## STAFF RECOMMENDATION 1307 Beechwood Avenue February 19, 2020

**Application:** New Construction—Addition  
**District:** Belmont-Hillsboro Neighborhood Conservation Zoning Overlay  
**Council District:** 18  
**Base Zoning:** R8  
**Map and Parcel Number:** 11801001200  
**Applicant:** Stephen and Mary Holby  
**Project Lead:** Melissa Baldock, [Melissa.baldock@nashville.gov](mailto:Melissa.baldock@nashville.gov)

<p><b>Description of Project:</b> The applicant proposes a rear addition.</p> <p><b>Recommendation Summary:</b> Staff recommends approval of the project with the following conditions:</p> <ol style="list-style-type: none"><li>1. The addition be inset a minimum of two feet (2') on both sides at the second level;</li><li>2. The primary roof slope be at least 6/12;</li><li>3. Window openings be added to the right façade, ground floor, where there is a twenty-foot (20') expanse of wall space without a window or door opening;</li><li>4. Staff approve the final details, dimensions and materials of windows and doors prior to purchase and installation;</li><li>5. Staff approve the roof shingle color; and</li><li>6. The HVAC be located behind the house or on either side, beyond

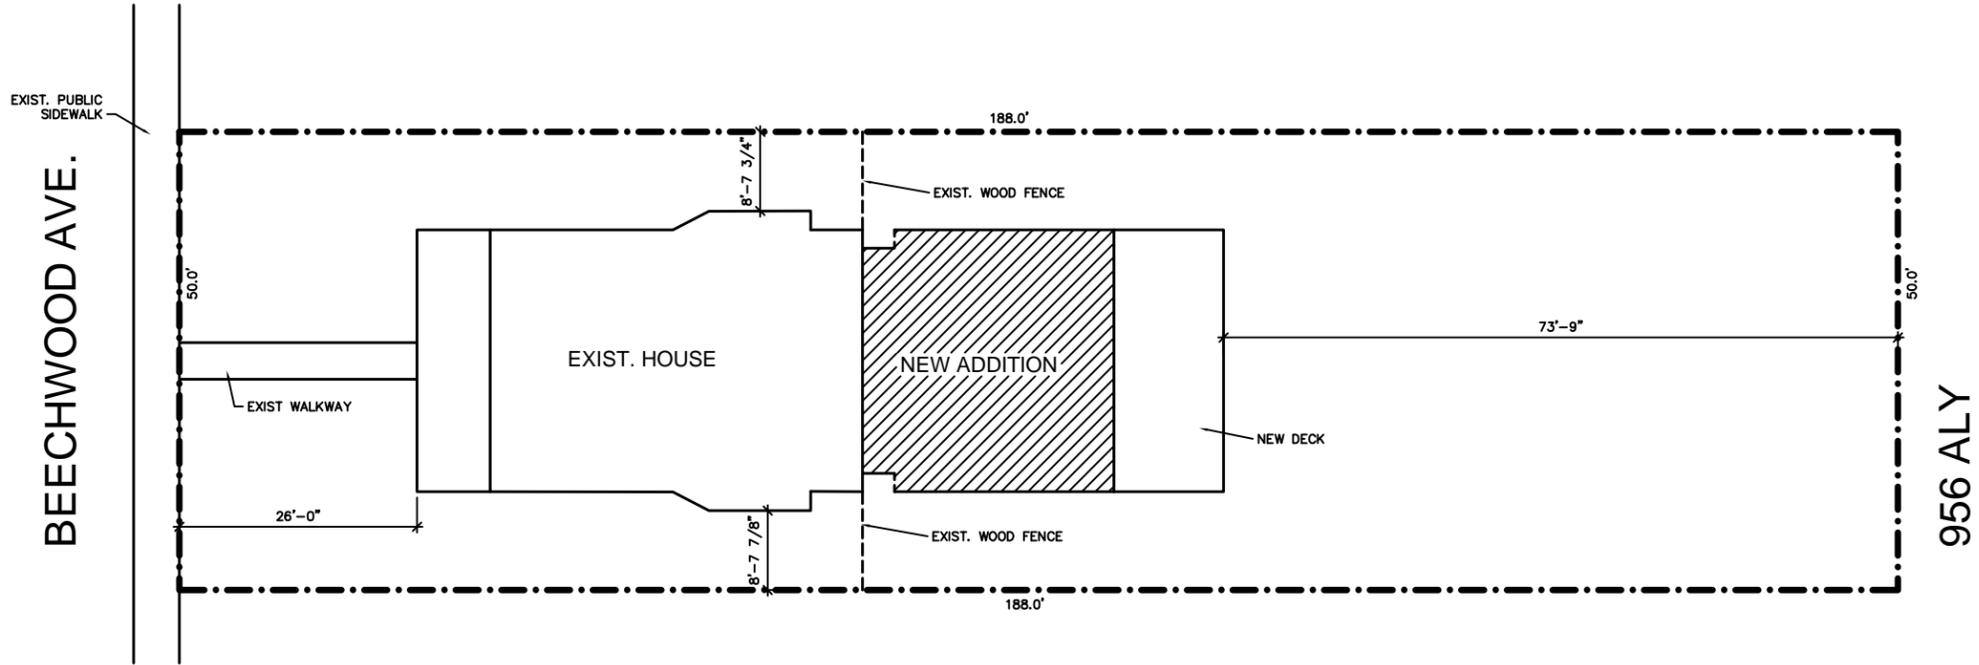
Proportion and Rhythm of Openings: No changes to the window and door openings on the existing house were indicated on the plans. The windows on the proposed addition are all generally twice as tall as they are wide, thereby meeting the historic proportions of openings. Staff recommends the addition of window openings on the ground floor of the right side since this is a twenty-foot (20’) wall expanse without a window or door opening.

With the addition of window openings on the ground floor, right façade, staff finds the project’s proportion and rhythm of openings to meet Sections II.B.1.g. and II.B.2. of the design guidelines.

REAR ELEVATION

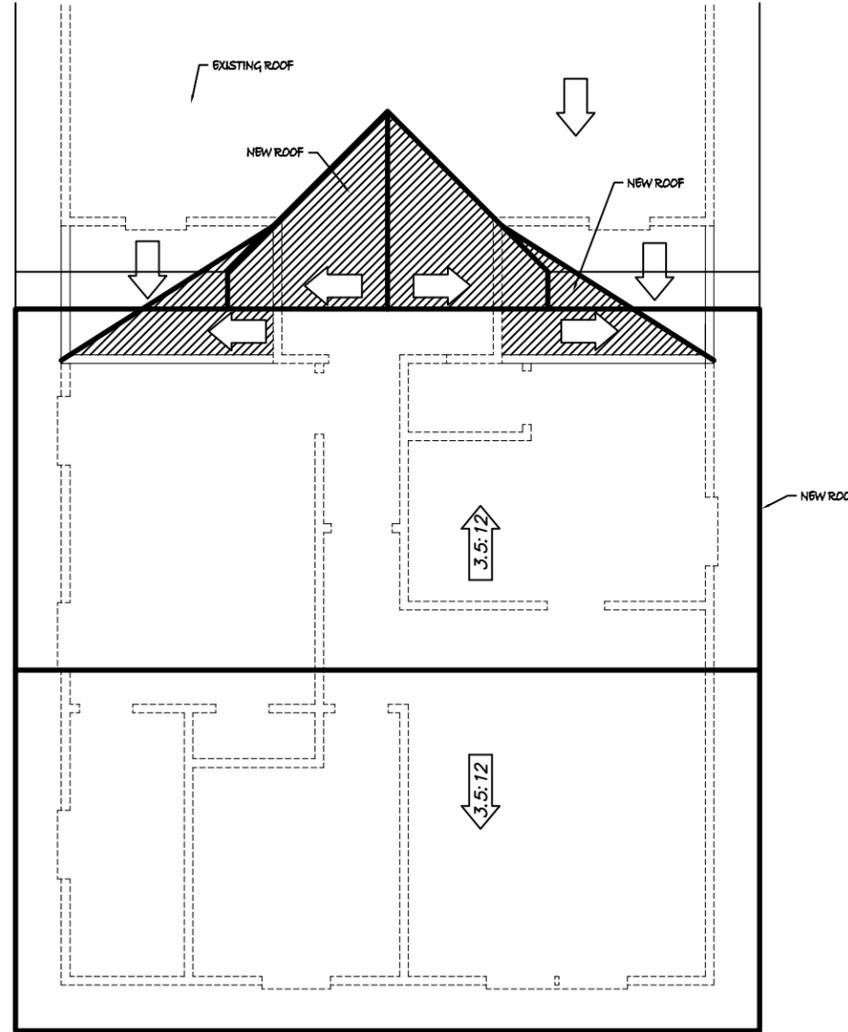
Roof form: The addition connects to the historic house’s roof with a hipped connection. The main form of the addition is a side gable with a 3.5/12 slope. The design guidelines state that roof forms should have a minimum slope of 6/12. The historic house has a side gable with a slope of approximately 6/12. Staff recommends that the primary roof forms have slopes of at least 6/12, in addition to the recommendation that the addition be inset two feet (2’) on both sides on the second level

With the condition that the addition’s roof have a slope of at least 6/12 and with the condition that the second level be inset a minimum of two feet (2’) on both sides, staff finds that the proposed roof forms meet Sections II.B.1.e. and II.B.2. of the design guidelines.

RIGHT SIDE ELEVATION

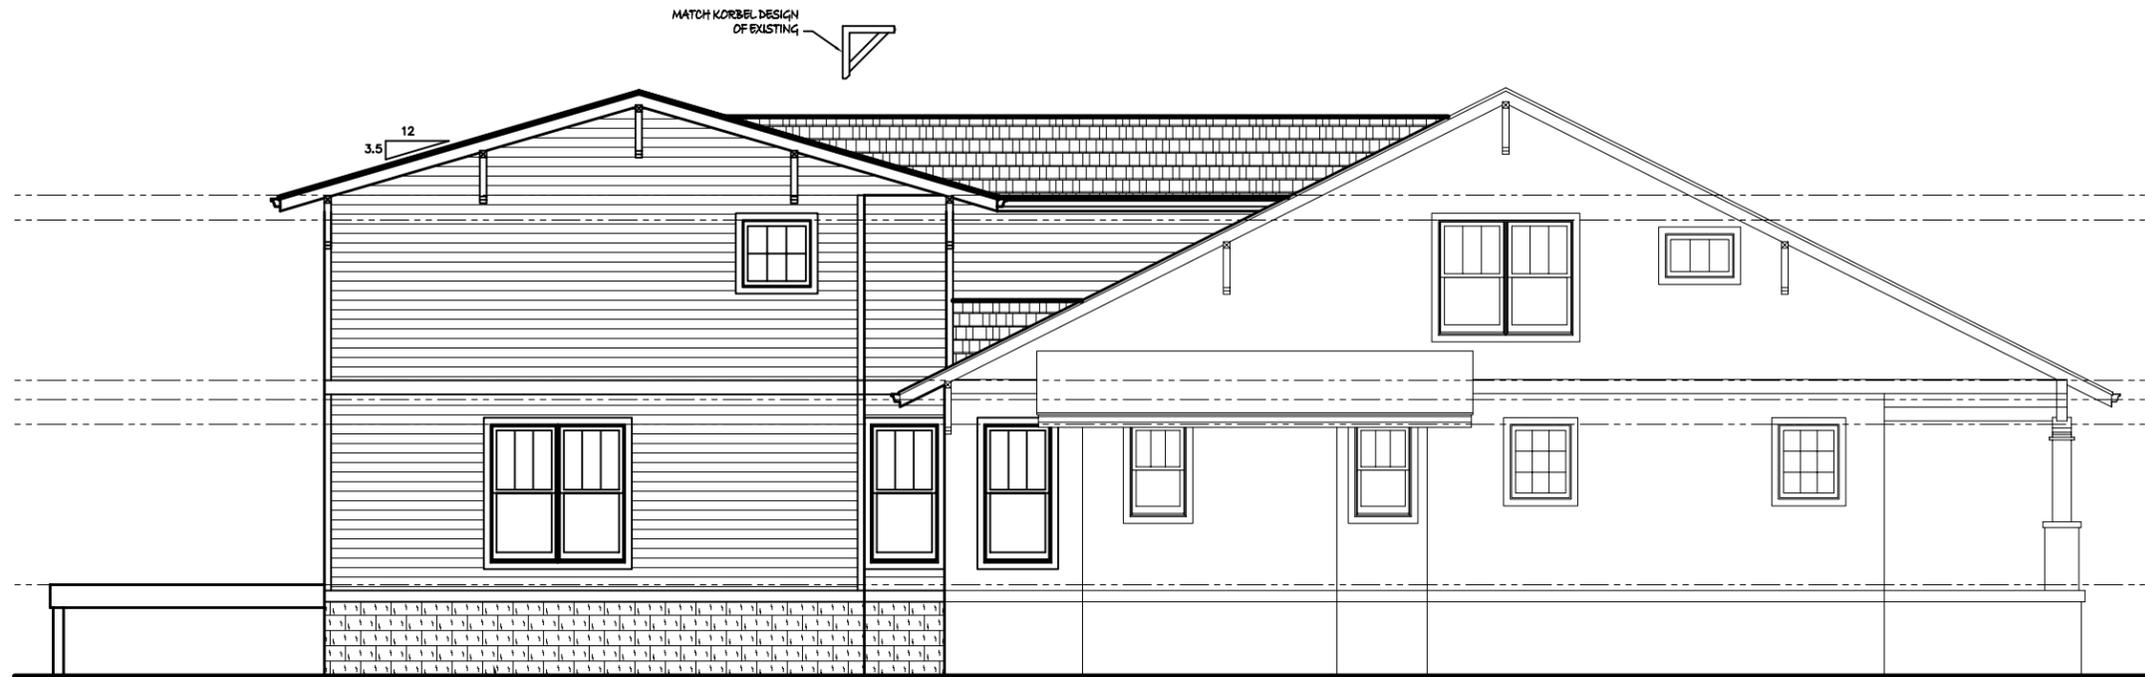
**Height & Scale:** The historic house is one-and-a-half stories in height, and the addition is a full two stories. The addition is inset two feet (2') at the back corners of the house for a depth of three feet, six inches (3'6"). After this depth, the addition steps back out to line up with the side walls of the historic house. Staff finds this to be appropriate on the first floor but recommends that the addition be inset a full two feet (2') for its entire depth on the second level because it has a larger scale. The two-story portion, which is not inset, will have an eave height that is approximately nine-feet (9') taller than the eave height of the historic house. It will have an eave height of approximately twenty feet (20'). Staff finds that the addition's two-story form is not appropriate unless at least the second level inset two feet (2') from the side walls of the house.

1. The addition be inset a minimum of two feet (2’) on both sides at the second level;

2. The primary roof slope be at least 6/12;
3. Window openings be added to the right façade, ground floor, where there is a twenty-foot (20') expanse of wall space without a window or door opening;
4. Staff approve the final details, dimensions and materials of windows and doors prior to purchase and installation;
5. Staff approve the roof shingle color; and
6. The HVAC be located behind the house or on either side, beyond the mid-point of the house.
